## CITY OF ST. AUGUSTINE CORRIDOR REVIEW COMMITTEE

### A G E N D A

THURSDAY, NOVEMBER 6, 2025 - 2:00 PM

WEST KING TOWNHOMES  
**King Street Corridor Review  
Committee Presentation**

LES THOMAS  
ARCHITECT  
32 CORDOVA ST., ST. AUGUSTINE, FLORIDA 824-9508

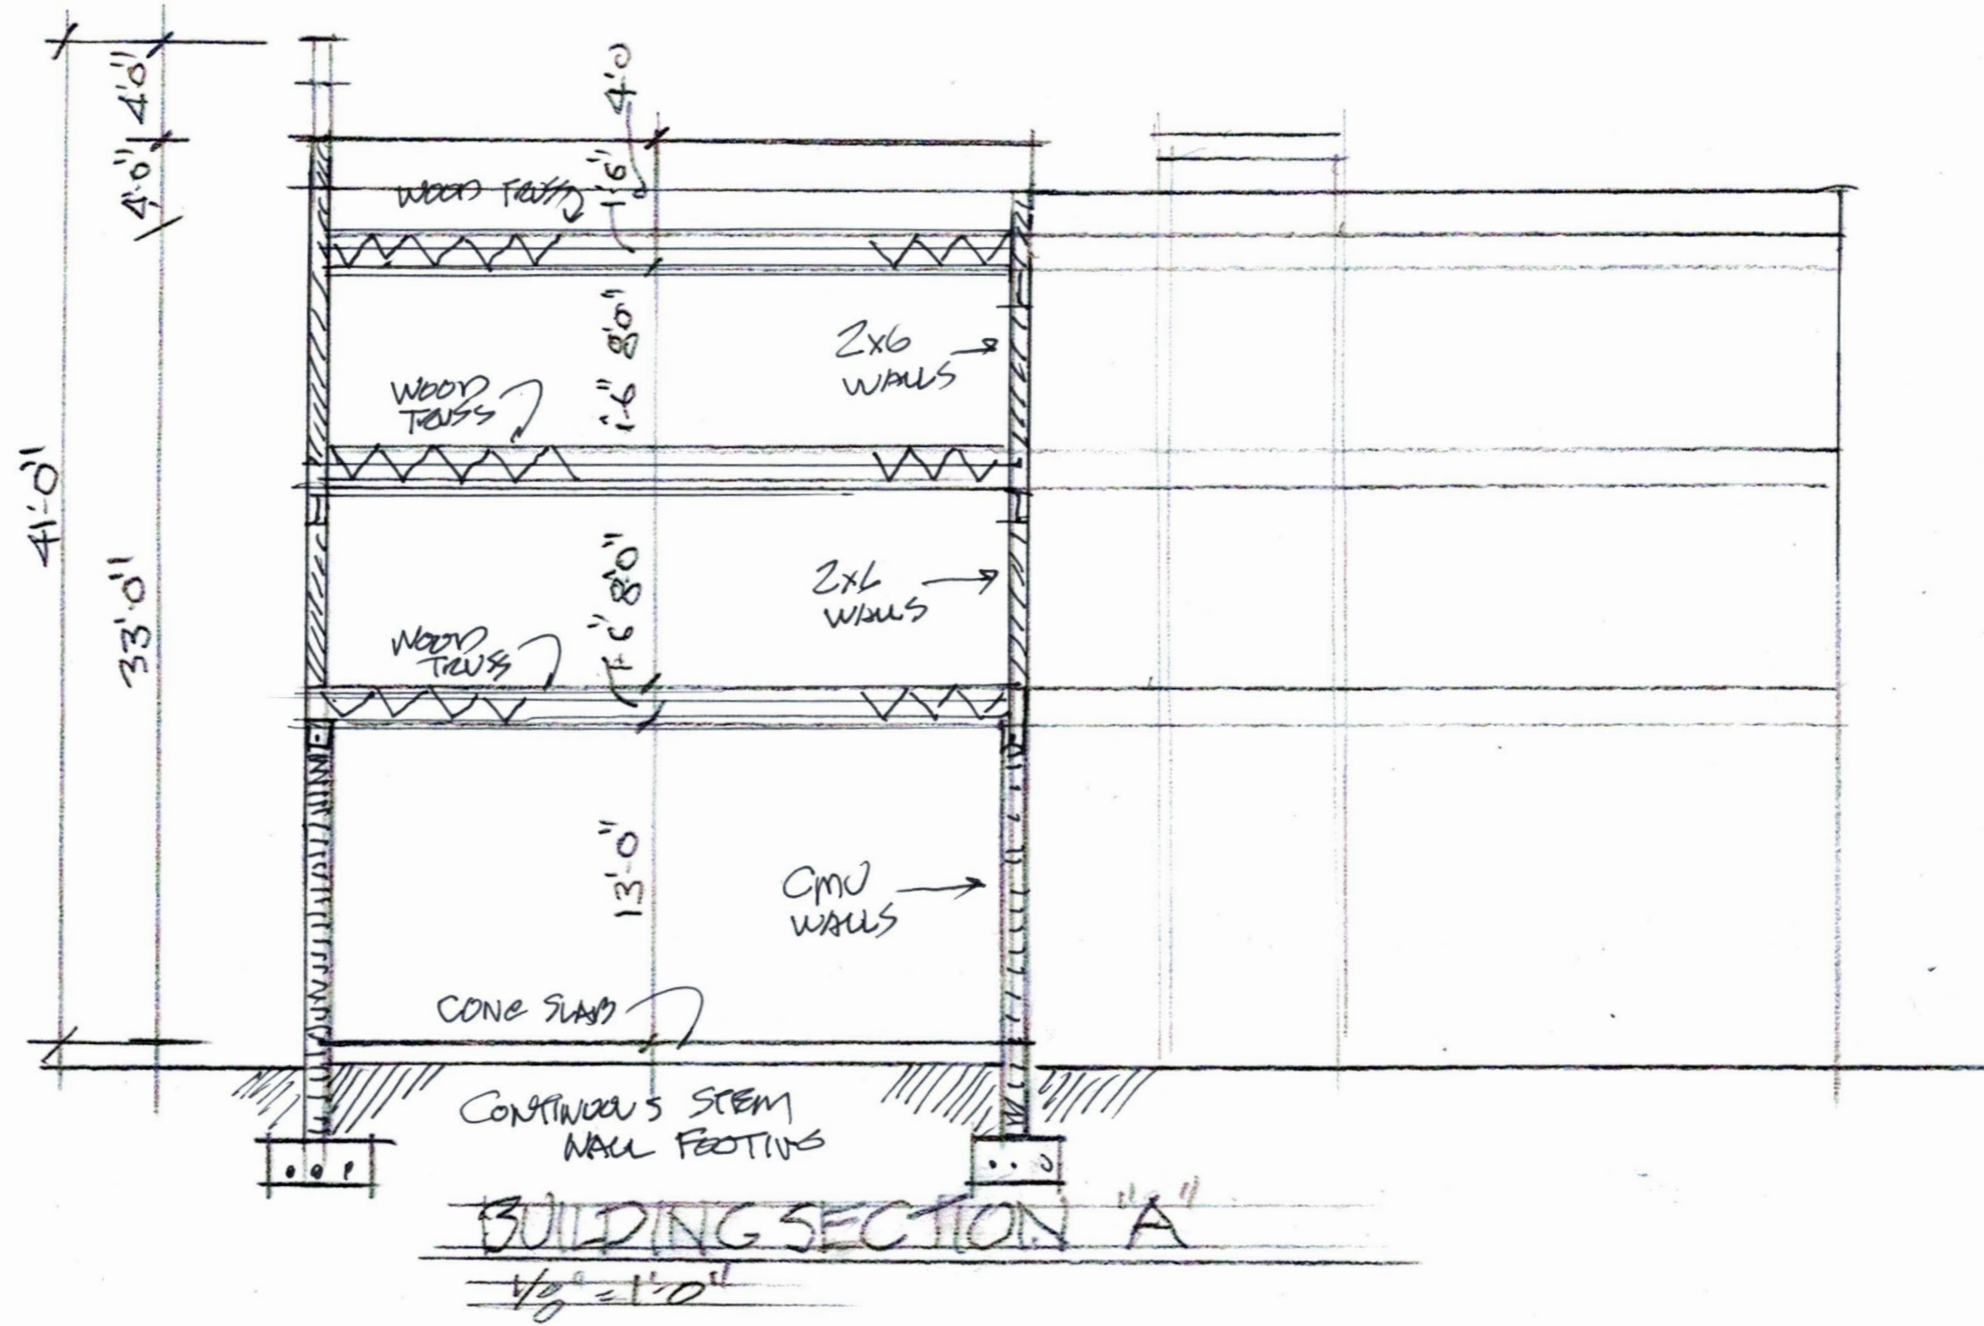
7. There are no color requirements in the W. King portion of the corridor. No specific colors were proposed with this application.
8. The DSEC states that openings, including porch openings, are counted in glazing calculations. Excluding the 24'x13.5' driveway opening, ground floor fenestration along W. King Street meets DSEC glazing requirements with no need for modification approval. If the driveway opening is included, the proposed glazing can be approved by the CRC as a modification to the standards. Window and glass door types are appropriate for the architectural style and the streetscape; however the two 6'x8' windows flanking the entry door do not appear to have an appropriate height bulkhead/kickplate which the standards state must be a minimum of 12".

SIZE: ANSI D  
 PRIME PROJECT #:  
 ML+H PROJECT #: 21.41.0  
 DRAWING NO. **L-3.1**

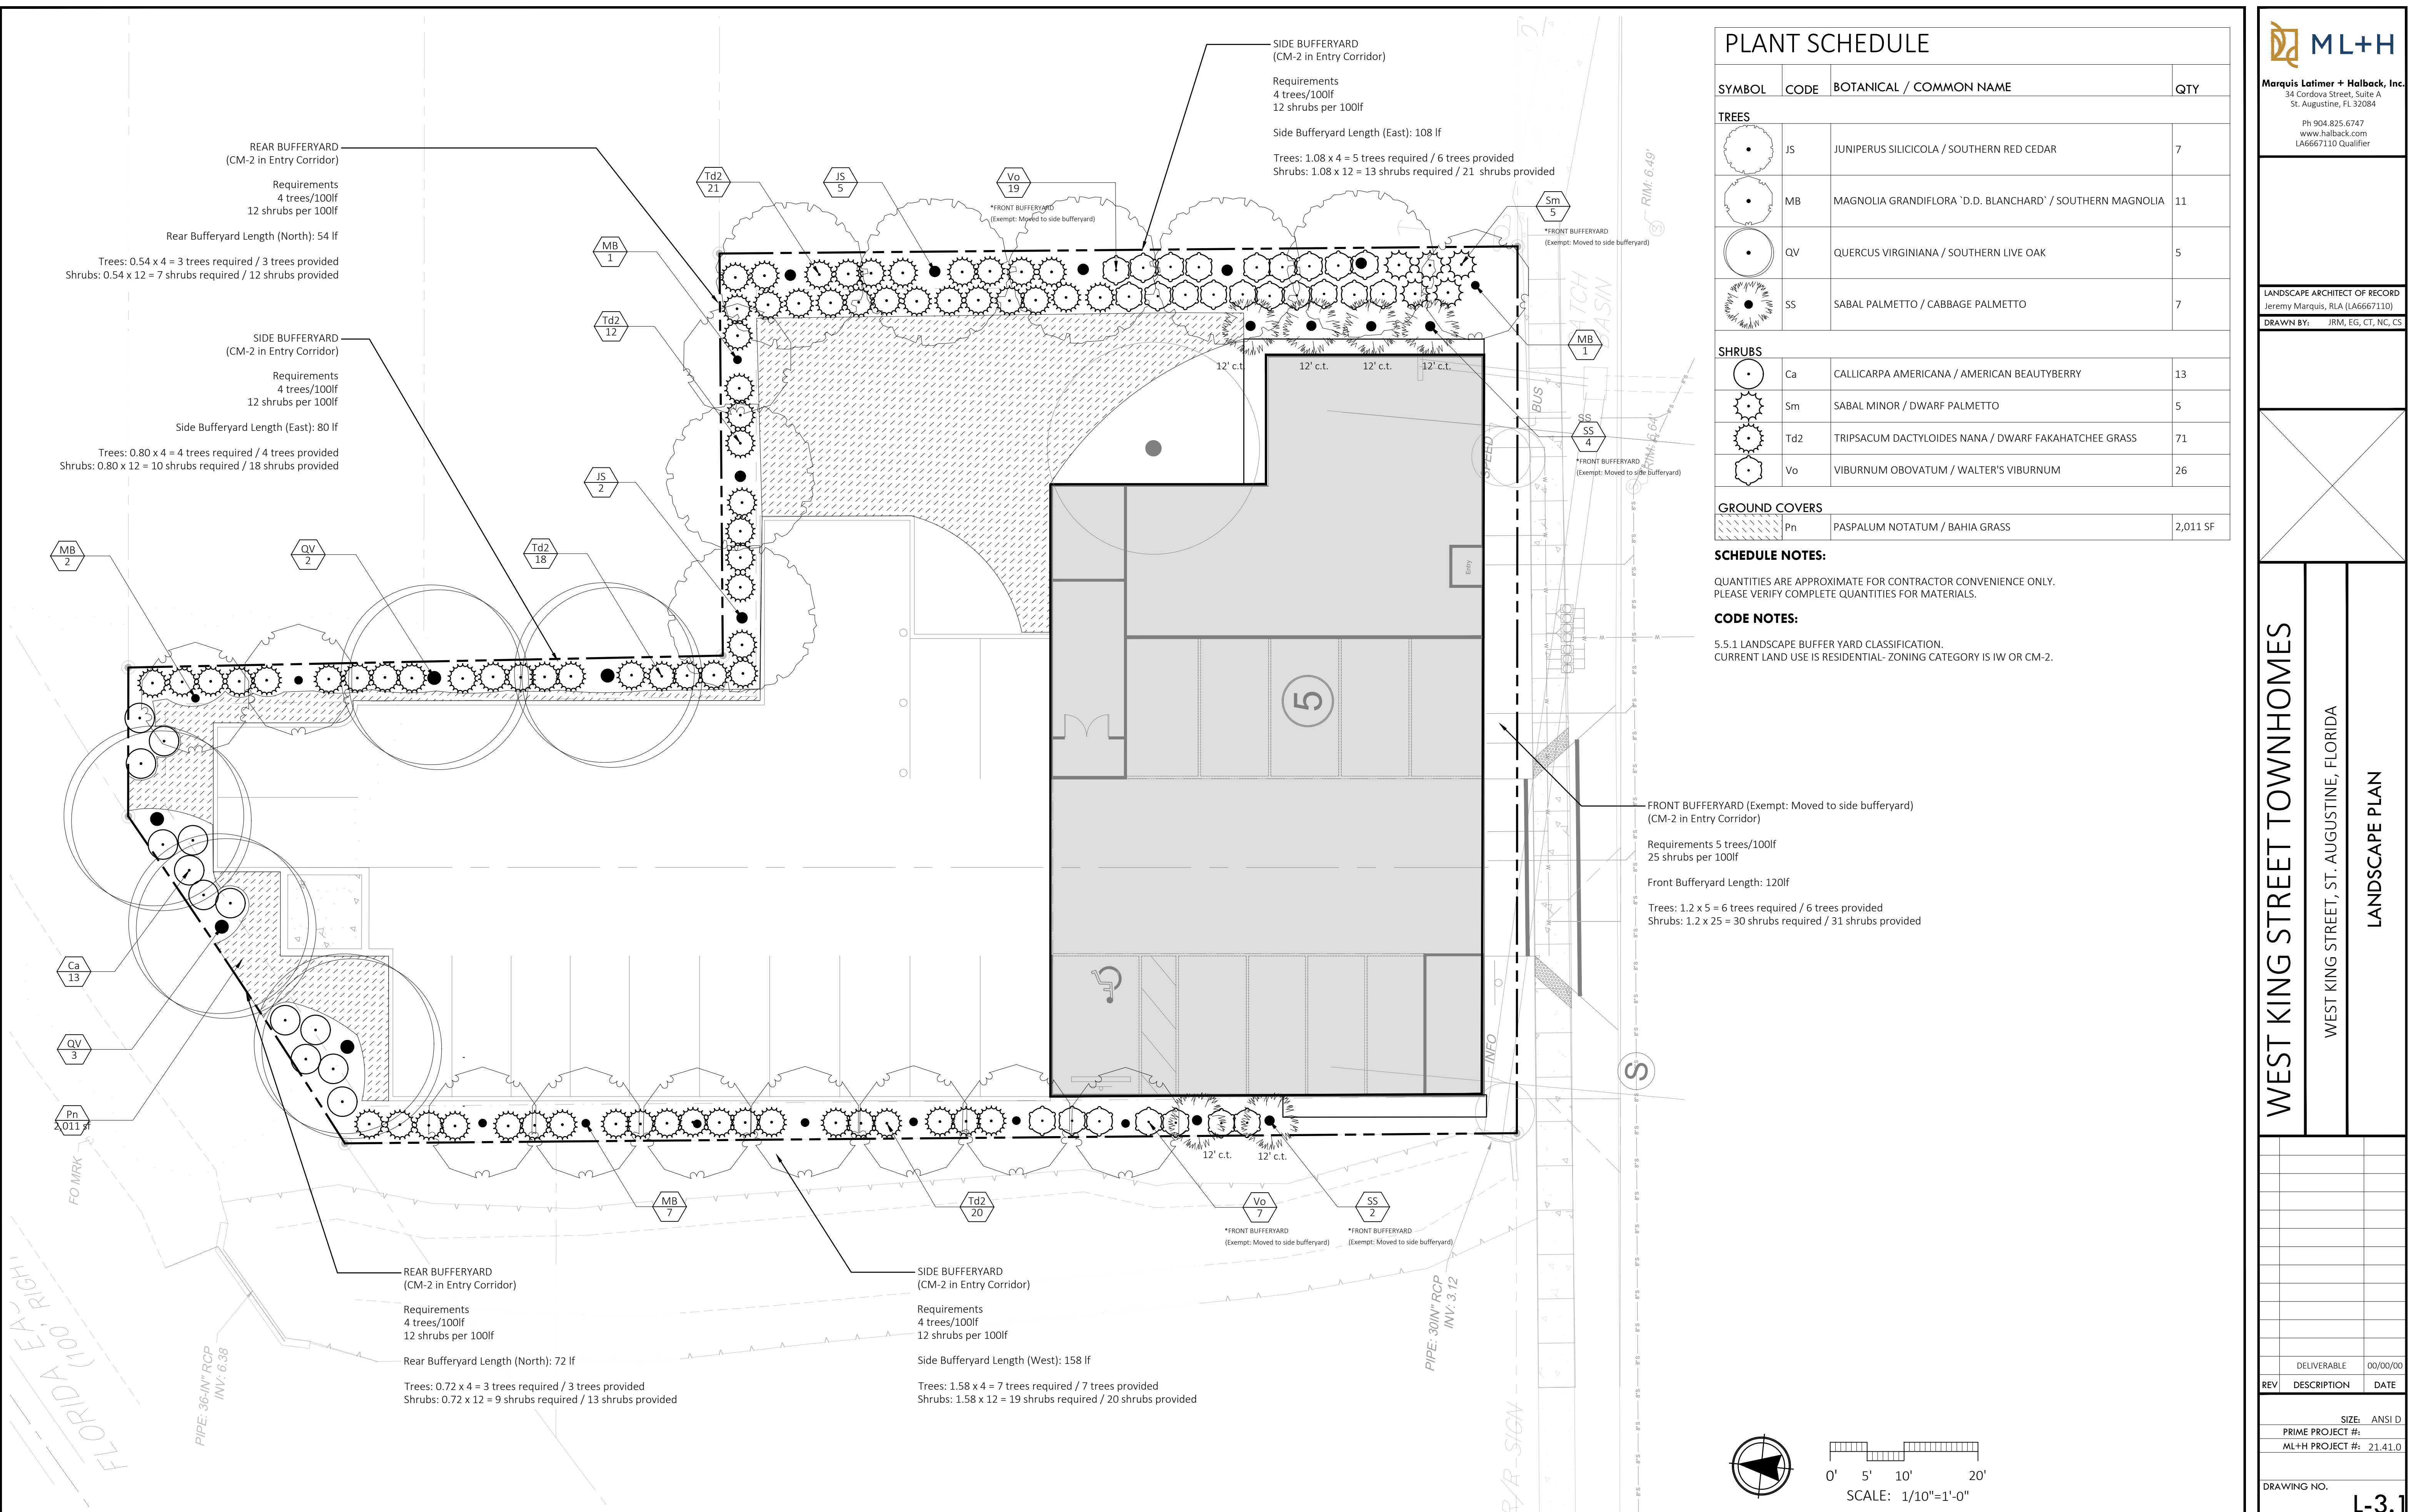
13. Side and rear buffer yards appear to meet requirements. The DSEC allows for required front yard plantings to be moved to side yards. Additional zoning review of proposed landscape plans will occur during the permitting process.
